SUBJECT: ISSUANCE OF AMENDMENT NO. 59 TO FACILITY OPERATING LICENSE NO. NPF-29 - GRAND GULF NUCLEAR STATION, UNIT 1, REGARDING USE OF AN ALTERNATE DECAY HEAT REMOVAL SYSTEM (TAC NO. 69403)

SAFETY EVALUATION BY THE OFFICE OF NUCLEAR REACTOR REGULATION

SUPPORTING AMENDMENT NO. 59 TO FACILITY OPERATING LICENSE NO. NPF-29

GRAND GULF NUCLEAR STATION, UNIT 1

FIGURE 1: ALTERNATE DECAY HEAT REMOVAL SYSTEM

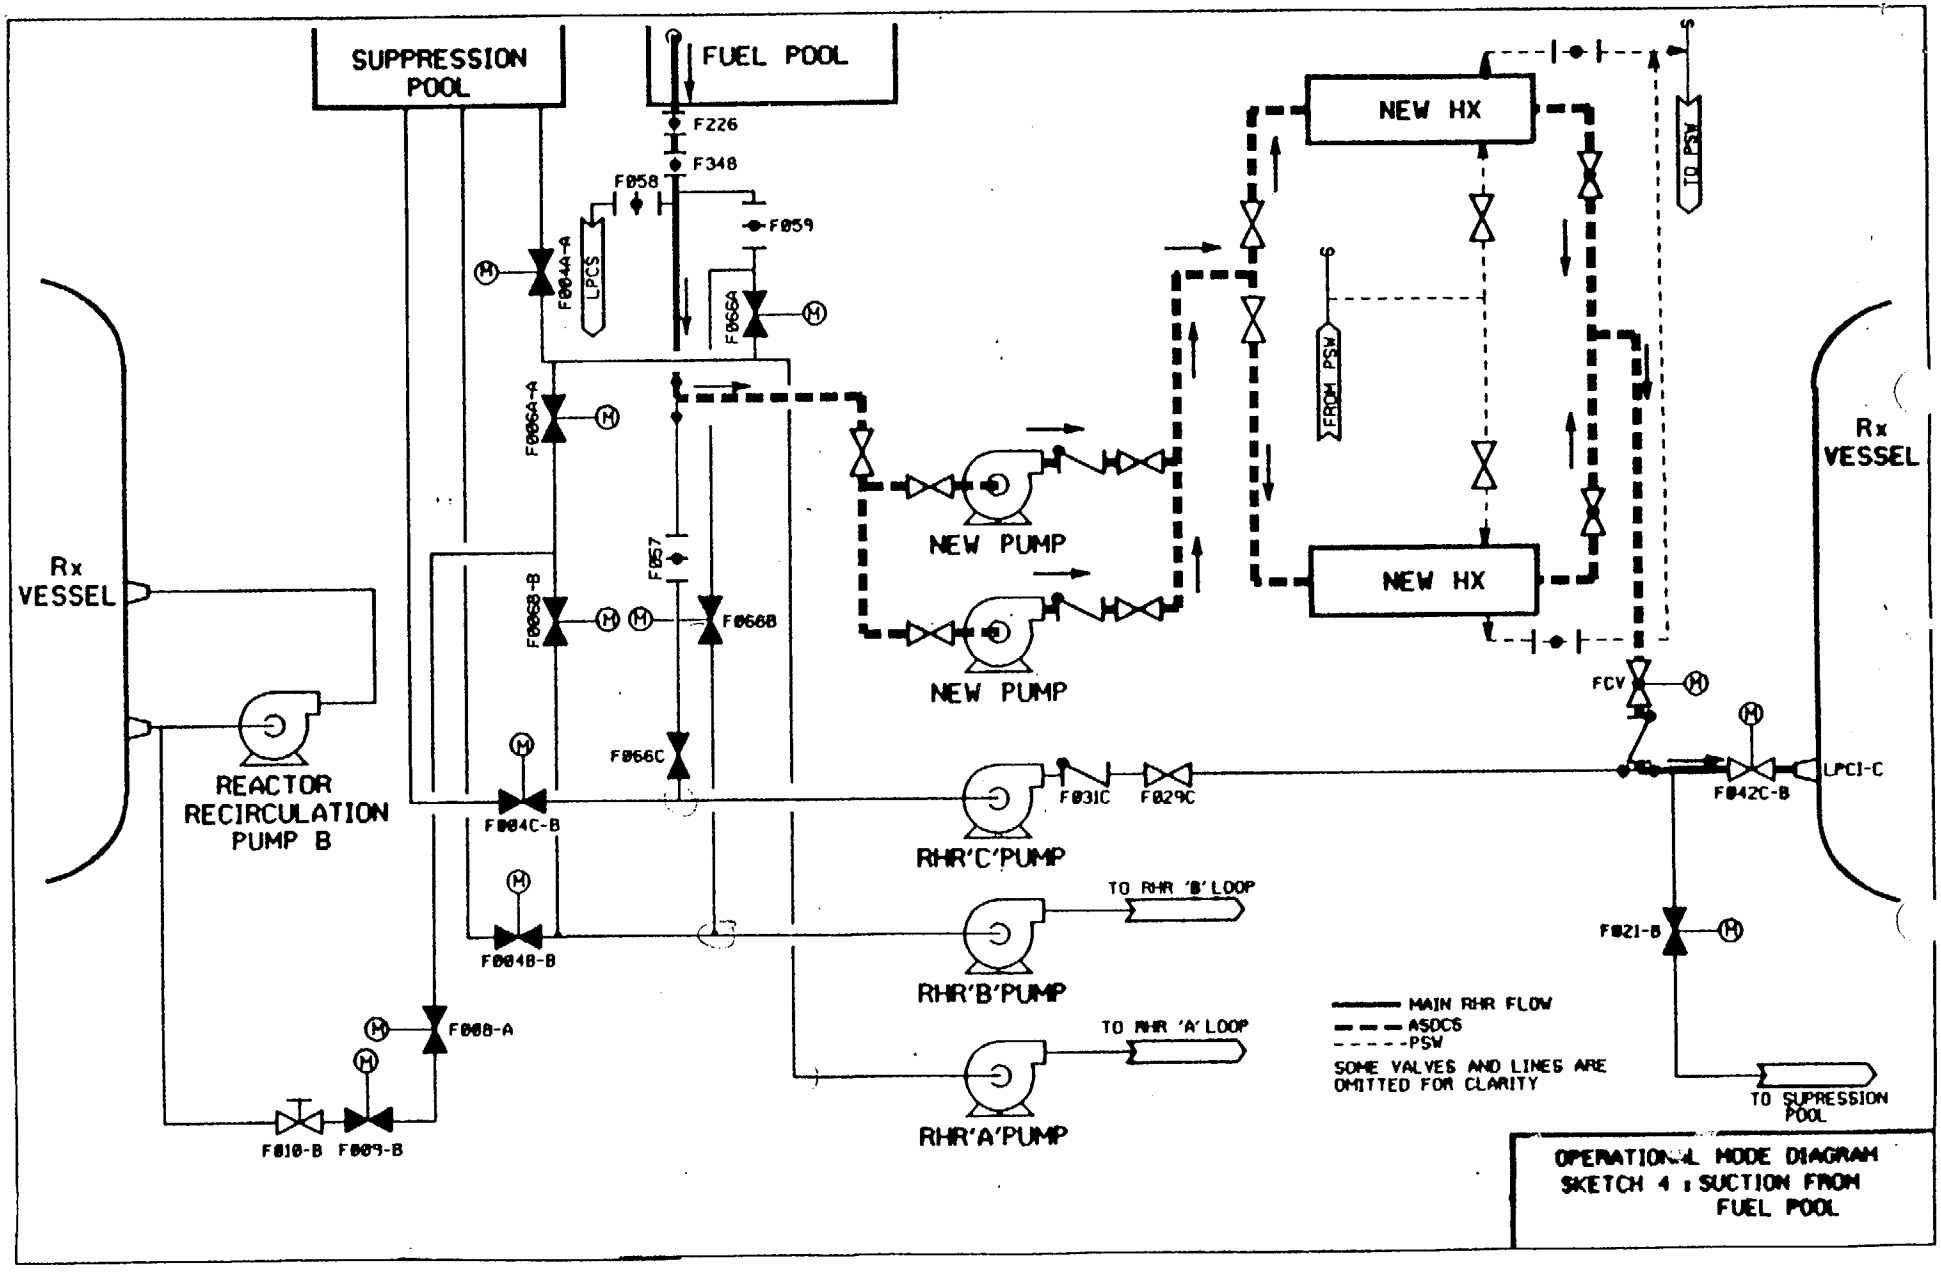
A flow diagram of the ADHRS is attached as Figure 1. The ADHRS consists of existing and new components. The existing components include the common RHR shutdown cooling suction line and fuel pool cooling and cleanup (FPCCU) piping. The new components include two ADHRS pumps, two heat exchangers, associated piping, valves, instrumentation and controls. A manually operated valve is added to isolate ADHRS from the FPCCU. In order to minimize the piping lengths, the new ADHRS equipment is located in RHR 'C' pump room. Functional control is provided from the main control room. The PSW system provides coolant to the ADHRS heat exchangers for heat removal. A radiation monitor with an alarm indicator in the control room is added to the PSW cooling water discharge header to detect intersystem leakage from a heat exchanger tube leakage or failure. Motor operators are added to valves E12F066A and B to allow the valves to be remote manually operated from the control room. The functional purpose of the ADHRS is important to safety, but is not safety related, since the ADHRS does not automatically mitigate the consequences resulting from accidents. However, safety-related components are used in various portions of the ADHRS to ensure that current safety-related requirements of the ECCS and RHR system are not compromised by the installation or use of the ADHRS.

In OC 4 and 5, more interactions are potentially possible between the ADHRS and the safety-related RHR shutdown cooling loops and ECCS subsystems. As shown in Figure 1, the ADHRS suction is connected to the fuel pool cooling and cleanup line which is joined to the RHR A, B and C loop suction piping. This results in the need for additional procedural controls and constraints to assure continued shutdown cooling and ECCS injection when the ADHRS is being operated.

FIGURE 2

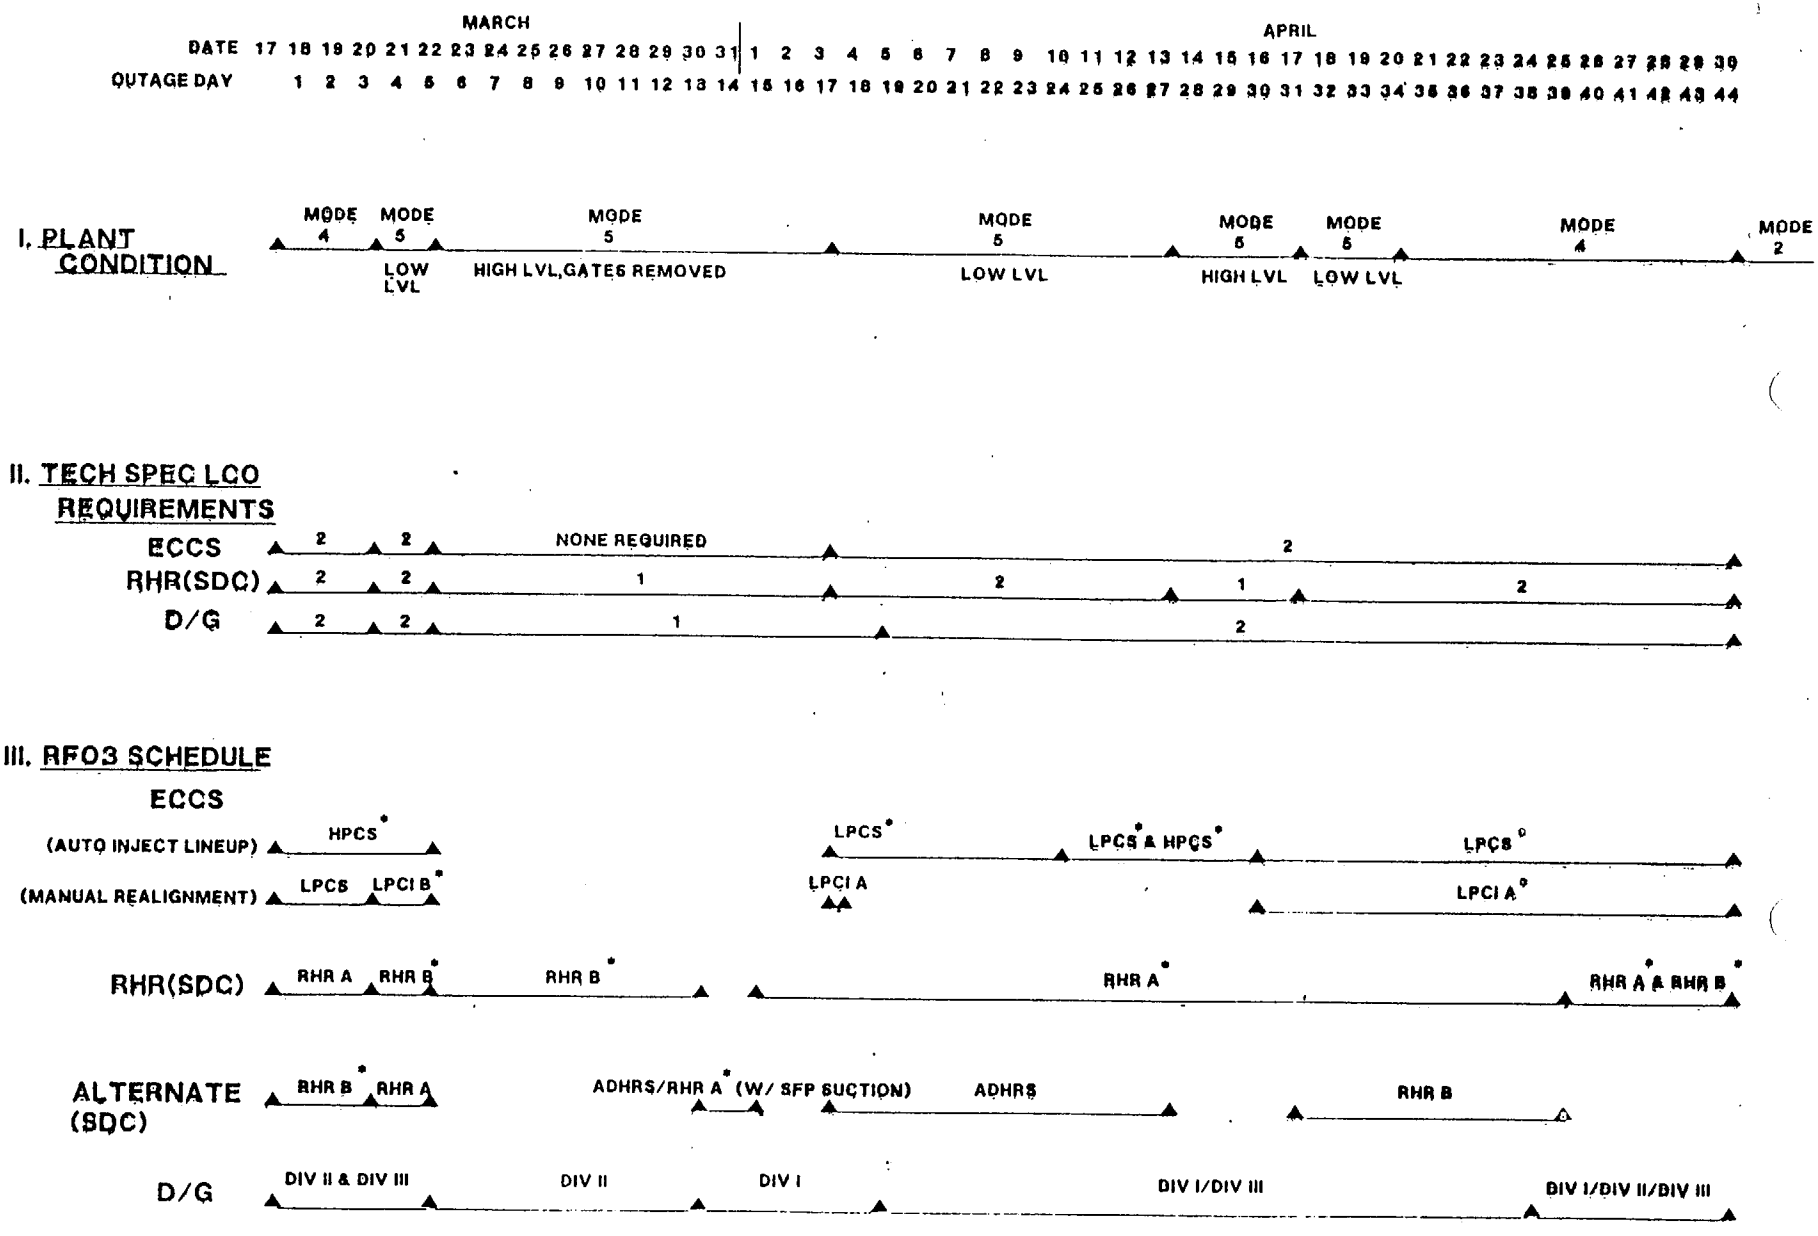
The ADHRS could be used during cold shutdown (OC 4) and refueling (OC 5) for shutdown cooling to supplement the residual heat removal function of the RHR system. The proposed use of the ADHRS together with the use of the RHR loops for shutdown cooling (SDC), the use of ECCS systems for water injection and associated diesel generators (DG) are shown for RF03 in Figure 2 (attached). Plant operational conditions (labeled MODE in Figure 2) are shown in Item I. TS LCO requirements for shutdown cooling loops (TS 3.4.9.2, TS 3.9.11.1, TS 3.9.11.2), ECCS subsystems (TS 3.5.2), and diesel generators (TS 3.8.1.2) are indicated in Item II of Figure 2. The scheduled ECCS subsystems, RHR loops, ADHRS and DGs are indicated in Item III of Figure 2.

Thus, for example, in the first two days of the outage (See Figure 2) while in OC 4 with the reactor pressure vessel head on, HPCS can be powered by DIV III DG and the alternate shutdown cooling loop RHR B can be powered by DIV II DG (indicated by an asterisk in Figure 2). The other two loops, LPCS and RHR A can only be powered by offsite power during this portion of the outage because the DIV I DG is undergoing maintenance. The ADHRS is designed for operation on offsite power only. In Item III of Figure 2, the RHR (SDC) line shows which RHR loops are operable. The Alternate (SDC) line shows the RHR loops that are not operable, but will be used as the "alternate method capable of decay heat removal" allowed in Action a of TS 3.4.9.2, TS 3.9.11.1 and TS 3.9.11.2, when an RHR train is not operable.
